February 14, 2020

**Subject: CARB's Newly Proposed Alternative Diesel Fuel (ADF) Testing Protocol**

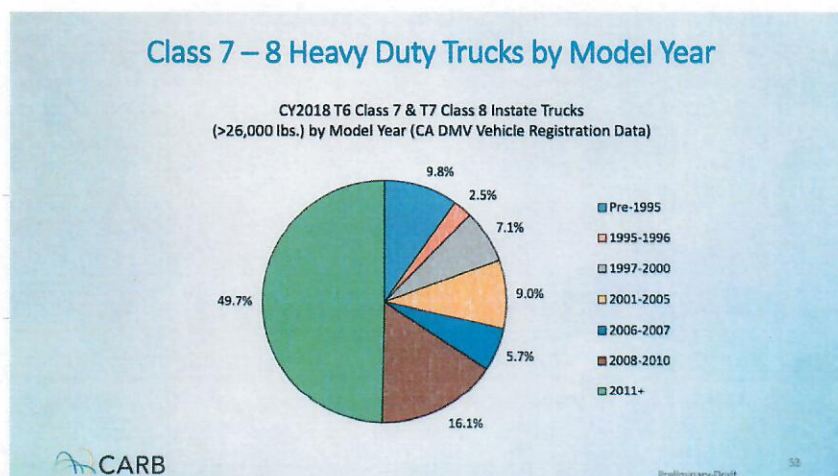
In October 2019, CARB delivered a webinar entitled “EMFAC202x, An Update to California On-road Mobile Source Emissions Inventory”. As indicated in the presentation slide provided on page 2, pre-1995 vehicles make up approximately 10% of the population. While the heavy-duty vehicle population for the 2004-2006 period is not reported, it is highly likely that the pre-1995 and the 2004-2006 vehicle populations are similar in size. We point this vehicle population comparison out because we believe that the S60 is just as representative of the California fleet as the Cummins. When you then factor in that the S60 produces more NOx emissions than the Cummins engine, the more important metric for NOx mitigant efficacy is an additive's performance in an S60.
